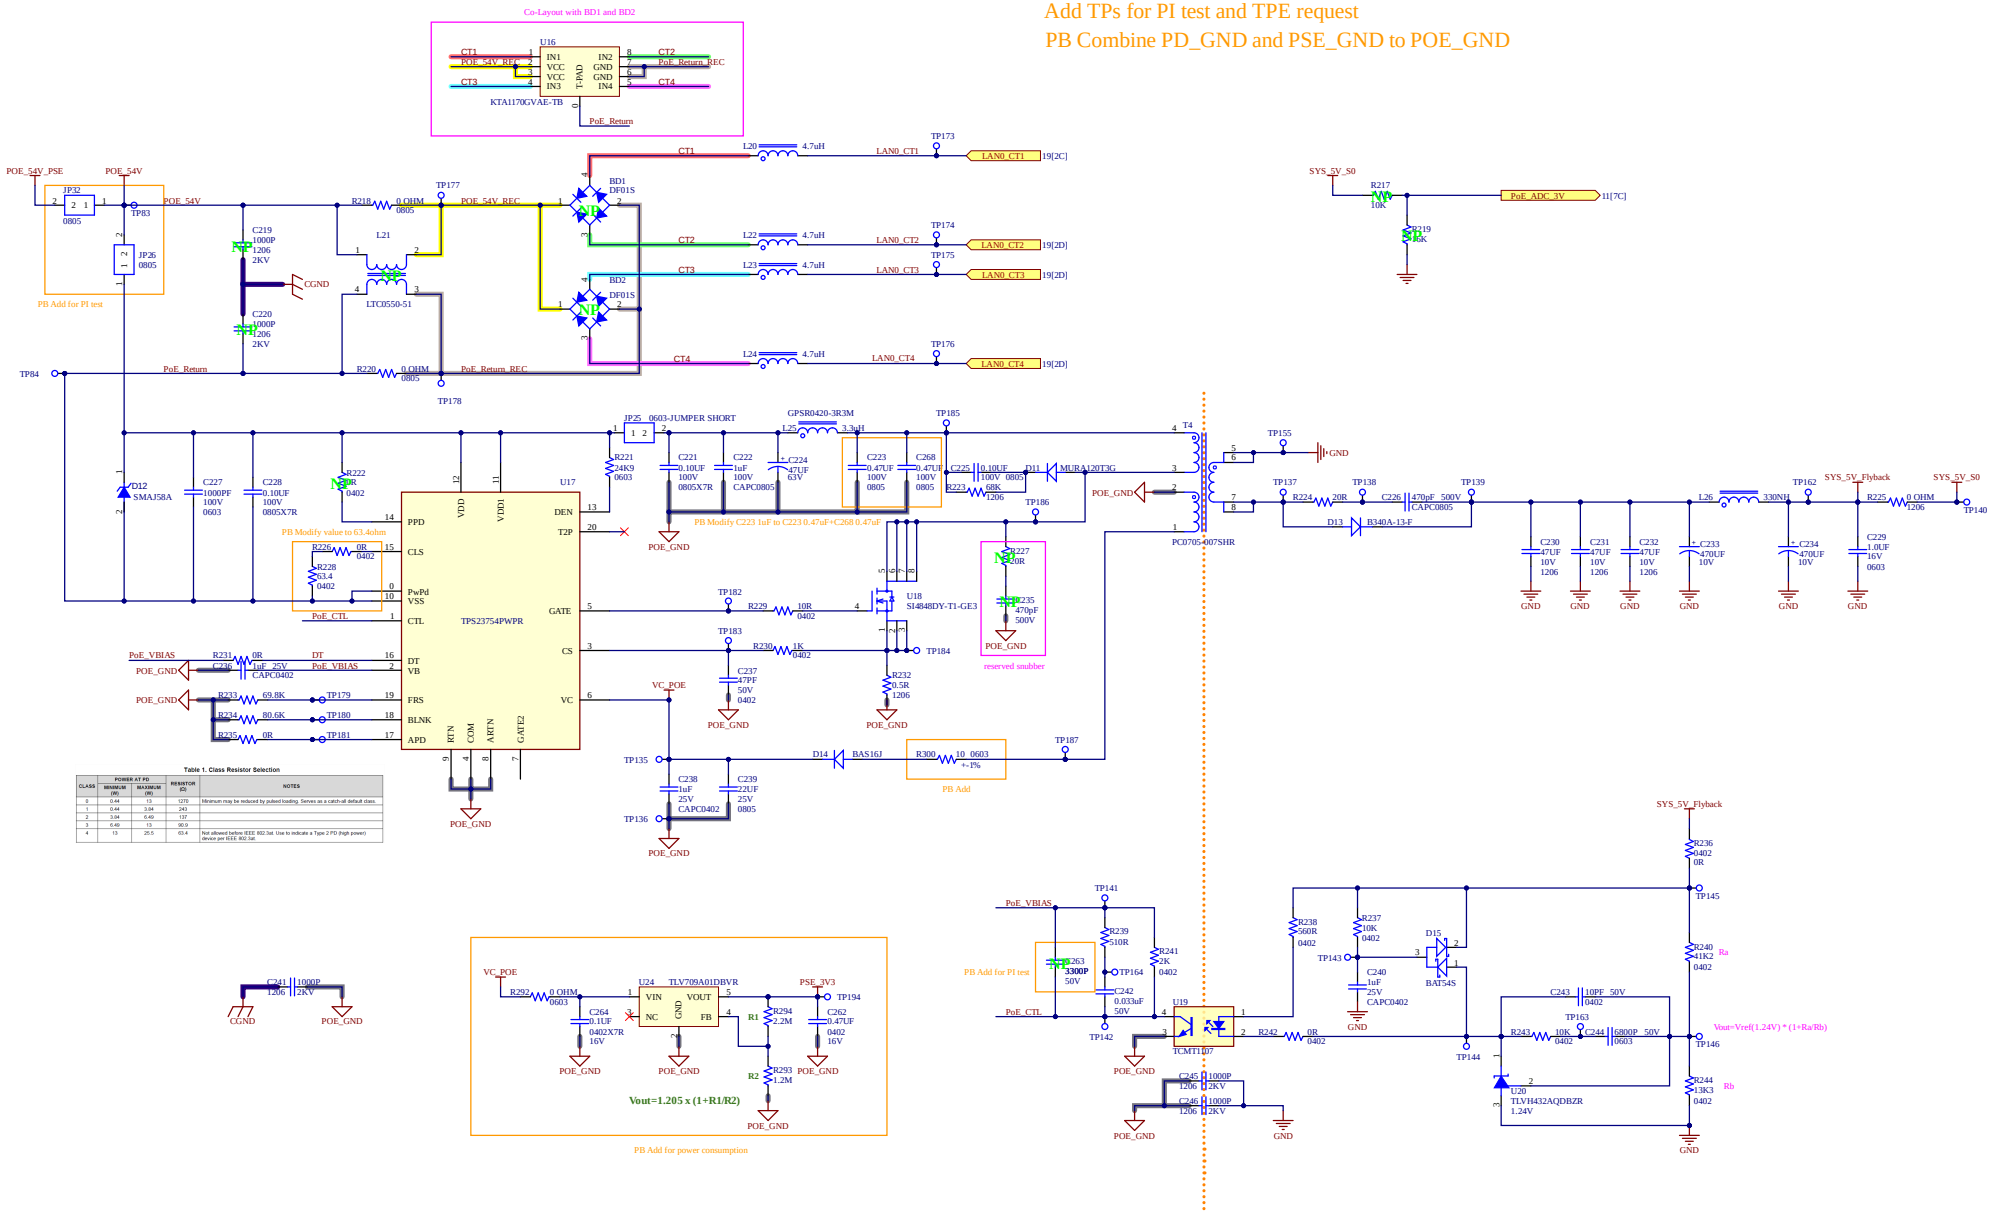
Add TPs for PI test and TPE request

PB Combine PD_GND and PSE_GND to POE_GND
